Dos Rios WRC Electrical System Improvements Project Phase 1
Solicitation Number: CO-00084
Job No.: 14-6504

ADDENDUM 5
October 5, 2016

SHEET
AB-C-1
SHEET 122 OF 166

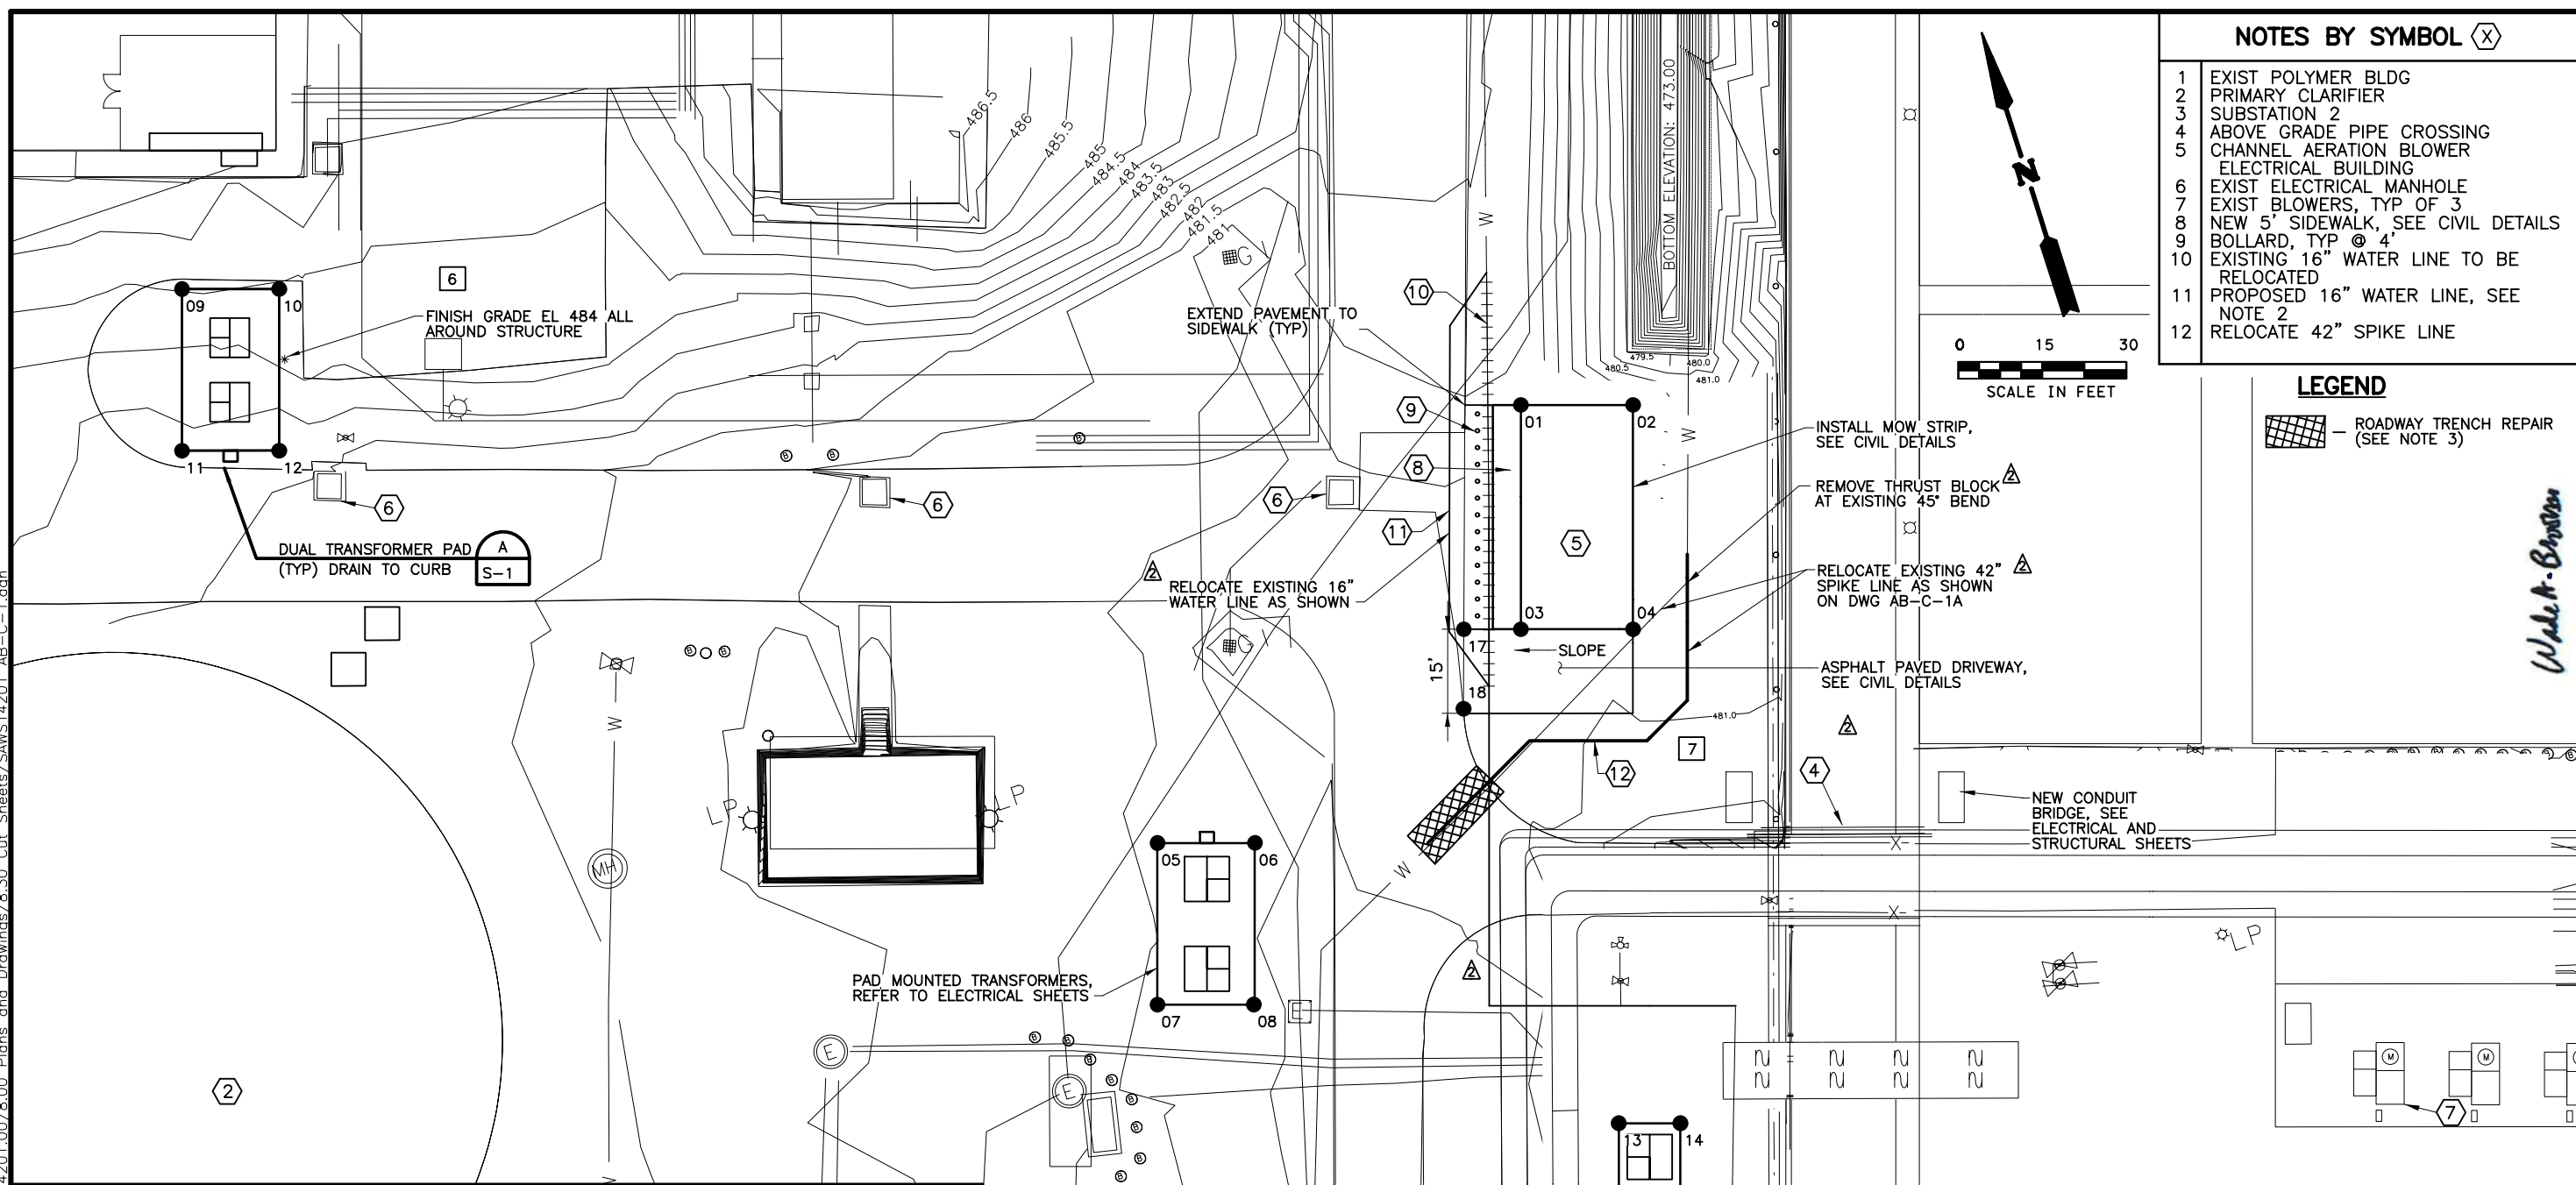
- 23. Drawing AB-C-1 Revision 1: Delete this drawing in its entirety and replace with the attached revised drawing AB-C-1 Revision 2.
- 24. Drawing AB-C-1A: Delete this drawing in its entirety and replace with the attached revised drawing AB-C-1A Revision 1.
